ORDINANCE NO. 3227

AN ORDINANCE OF THE CITY OF KIRKLAND RELATING TO LAND USE, APPROVAL OF A PRELIMINARY AND FINAL PUD AS APPLIED FOR BY JAMES MILLER IN DEPARTMENT OF PLANNING AND COMMUNITY DEVELOPMENT FILE NO. IIB-90-44 AND SETTING FORTH CONDITIONS OF SAID APPROVAL.

**DEPARTMENT OF PLANNING AND COMMUNITY DEVELOPMENT
ADVISORY REPORT
FINDINGS, CONCLUSION, AND RECOMMENDATIONS**

File: IIB-90-44, Miller Rezone and PUD

Primary Landscaping Plan

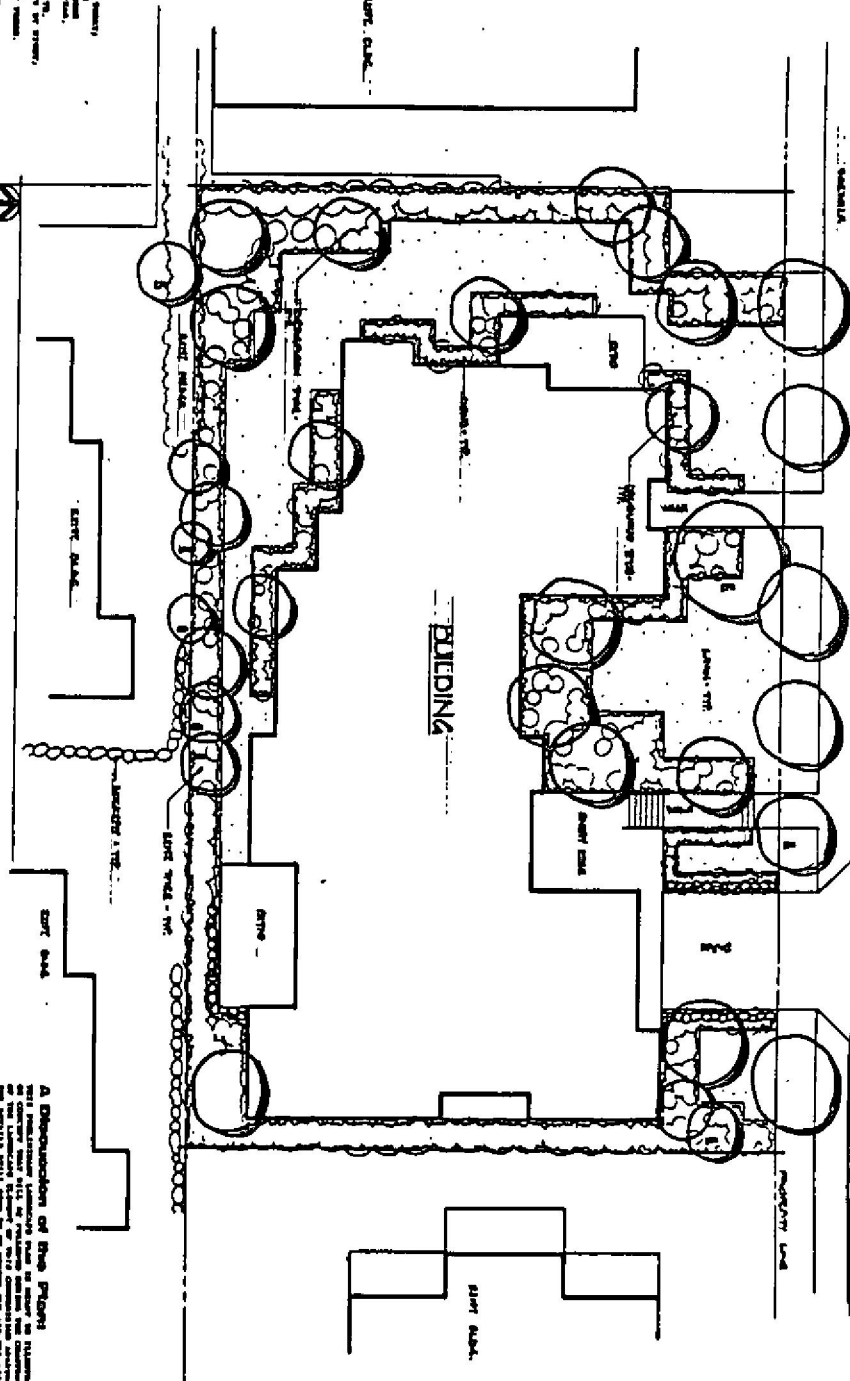
3. a. Fact: Section 20.10.a requires stacked dwelling units in an RM zone to comply with Landscape Category D. Section 95.10 lists the applicable regulations for Landscape Category D. Because the subject property is adjacent to single-family development to the north and west, the applicant must comply with Section 25.3. Buffering Standard 3 requires that the applicant plant one row of trees 8-10 feet on center and shrubs 18-inches high planted to attain a coverage of at least 60 percent of the buffer area within two years along the entire length of the 5-foot buffer along the north and west property lines (see Attachment 2.e).

- b. Conclusion: Pursuant to Section 95.10 and 95.25.3, the applicant should revise the landscape plan to meet the requirements of establishing a 5-foot wide buffer along the perimeter property line adjoining the north boundary and extend the 5-foot wide buffer along the west boundary to the north property line. The plan should be revised to indicate that within the buffer strips, trees 8-10 feet on center, and shrubs 18 inches high to attain at least a 60 percent lot coverage within two years should be planted. Specific landscape materials should be called out. The pavement

4. a. Fact: Special Regulation No. 3 of Section 20.10.a requires the applicant to provide 200 square feet per unit of common recreational open space usable for many activities. Therefore, the minimum required area for 5 units is 1,000 square feet. The minimum dimensions for five units is a minimum of 800 square feet per piece and having a length and width of at least 25 feet. The required common recreational open space may be reduced to 150 square feet per unit if permanent outdoor furniture, pool, cooking facilities, playground equipment and/or a recreation building are provided in the common open space. The City shall determine if these outdoor provisions provide comparable recreational opportunities as would the open space that is reduced. The site plan indicates the location of the common recreational open space near the southwest portion of the subject property. The landscape plan shows trees and shrubs encroaching into the common recreational open space of at least 1,000 square feet in size or in the alternative, a reduced area providing permanent outdoor amenities as described above.

- b. Conclusion: Pursuant to Special Regulation 3.a, the landscape plan should be revised to delete trees and shrubs and other landscape materials other than grass to meet the minimum criteria for establishing a common recreational open space of at least 1,000 square feet in size or in the alternative, a reduced area providing permanent outdoor amenities as described above.

- b. Revised site and landscape plans indicating
 - 1) A 5-foot wide Type 3 landscape buffer planted to meet the specifications of Section 95.25.3 along the north and west property lines and deletion of the existing paved parking area in the northwest corner of the subject property

- 2) A common recreational open space area meeting the dimensional specifications of Section 20.10.a, Special Regulation No. 3, and
 - 3) The types and sizes of landscape materials being used in this project to be approved by the Department of Planning and Community Development (see Conclusion II.D.3.b and 4.b).
